SEB Issue List Regarding APR1400 DC FSAR 3.7.1

Issue #1 (AI 3-74.1)

APR1400 DCD TIER 2**3.7.1.1 Design Ground Motion**

Figure 1 Comparison of the Horizontal Target PSD Compatible with APR1400 HRHF Horizontal Response Spectra with the SRP 3.7.1 PSDs for CEUS Rock Sites

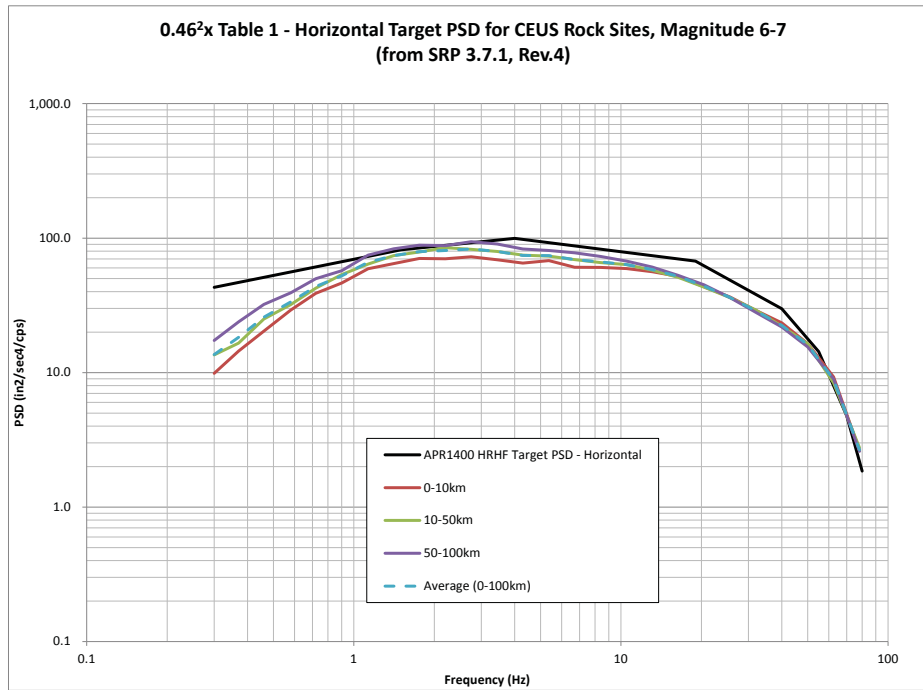
Section 3.5.1 of APR1400-E-S-NR-14004-P, Rev. 1, "Evaluation of Effects of [hard rock high frequency] HRHF Response Spectra on SSCs," compares the APR1400 HRHF horizontal target PSD with the target PSD curves presented in Appendix B of the SRP 3.7.1 Draft Rev. 4, as shown in Figure 3-24 of this report. The PSD tables in Appendix B of the SRP 3.7.1 Draft Rev. 4 were determined to have typos and those target PSDs are generally not compatible with the bin average response spectra. Appendix B of SRP 3.7.1 has been revised in Rev. 4 to address these issues and the guidance in SRP 3.7.1 has been updated. Therefore, comparison to the data in those tables in Appendix B of the SRP 3.7.1 Draft Rev. 4 is not considered to be appropriate and the HRHF report should be revised, as appropriate.

The PSDs presented in Appendix B of SRP 3.7.1 Draft Rev. 4, used for comparison with the APR1400 horizontal target PSD compatible with the HRHF horizontal DRS, will be revised to the PSDs presented in Appendix B of SRP 3.7.1 Rev. 4, as shown in Figure 1. This revised figure of comparison will replace the corresponding figure in Section 3.5.1 of APR1400-E-S-NR-14004-P, Rev. 1.

Figure 3-24 Comparison of the Horizontal Target PSD Compatible with APR1400 HRHF Horizontal Response Spectra with the SRP 3.7.1 PSDs for CEUS Rock Sites

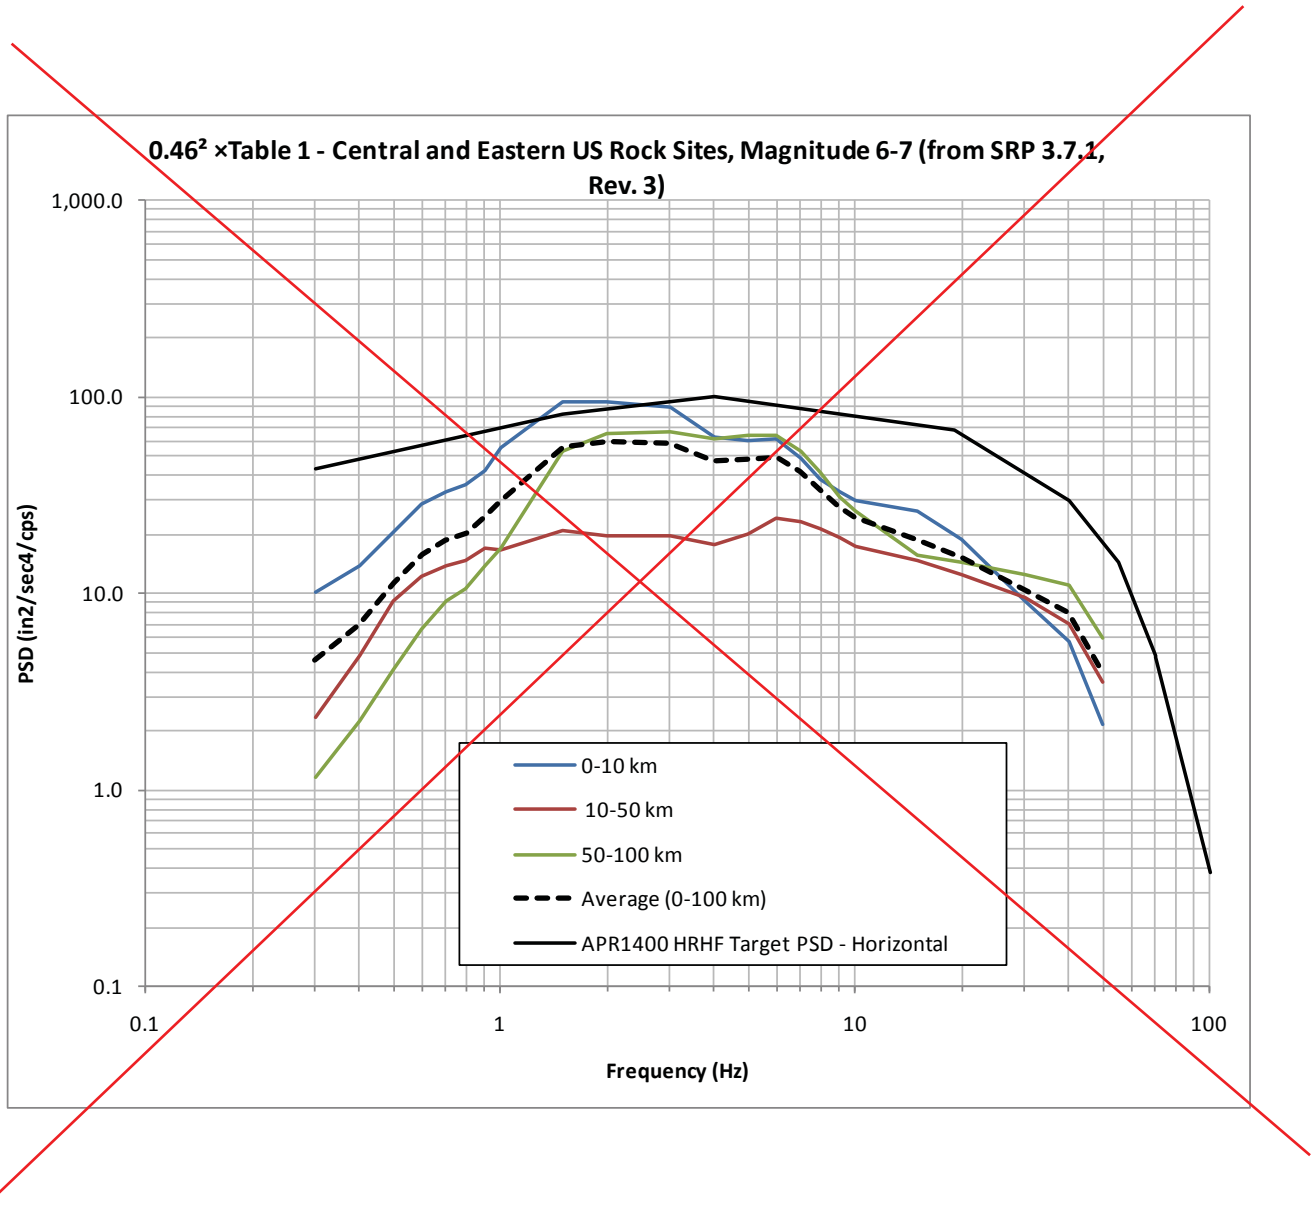
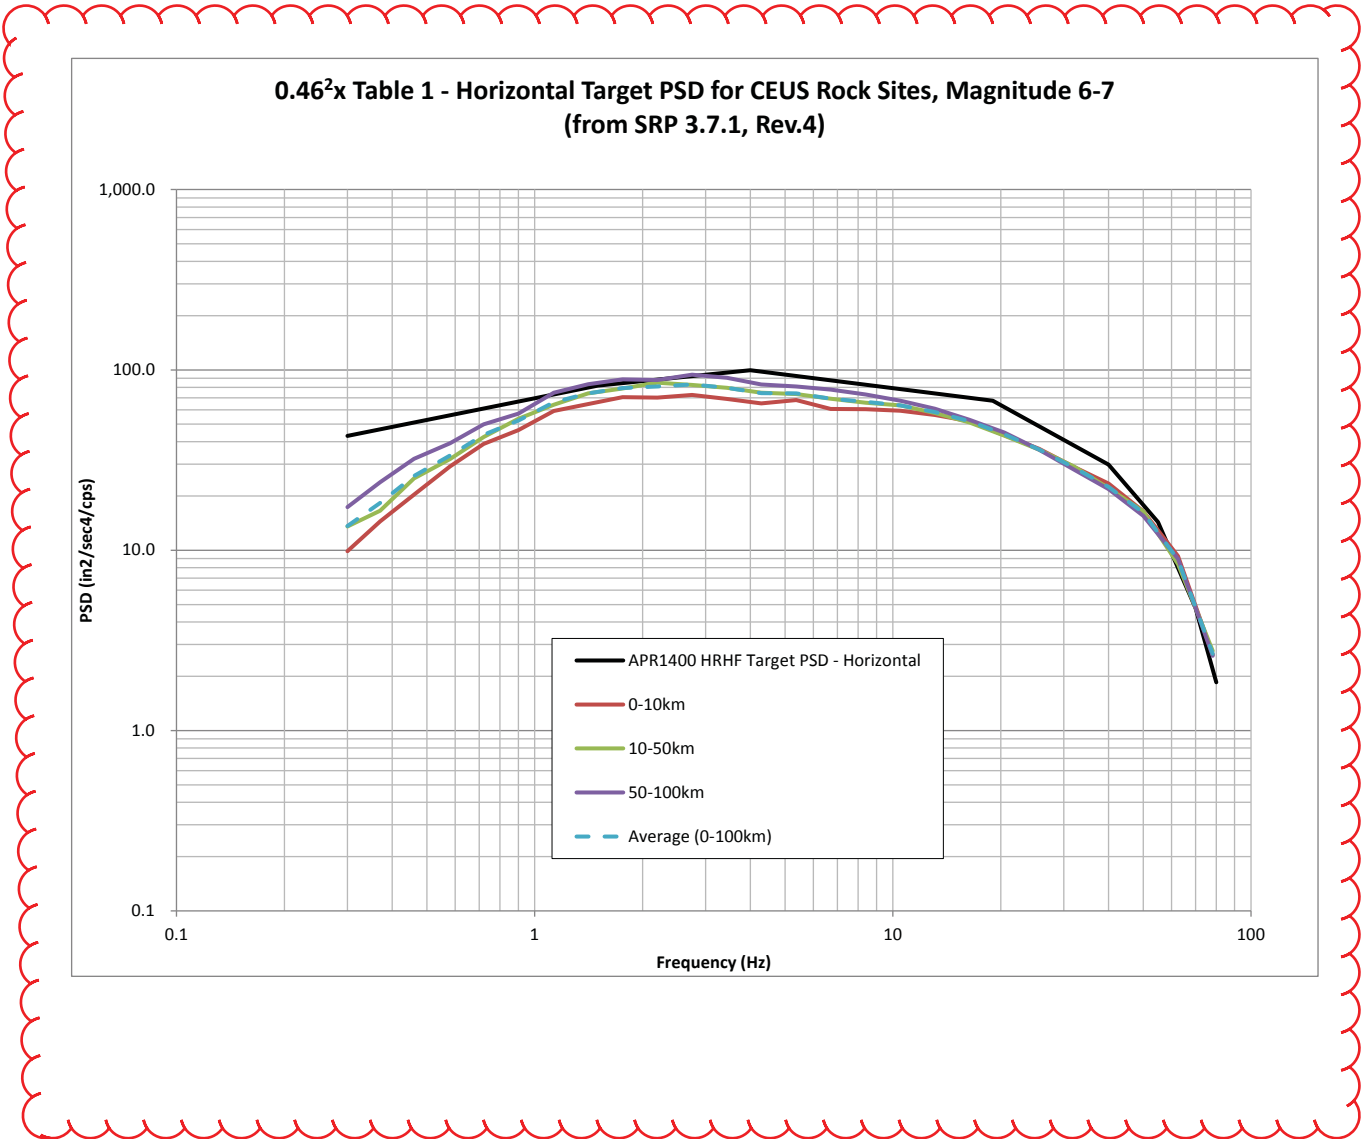
Technical report, APR1400-E-S-NR-14004-P/NP, Rev. 1, Figure 3-24 will be revised as indicated on the attached markup
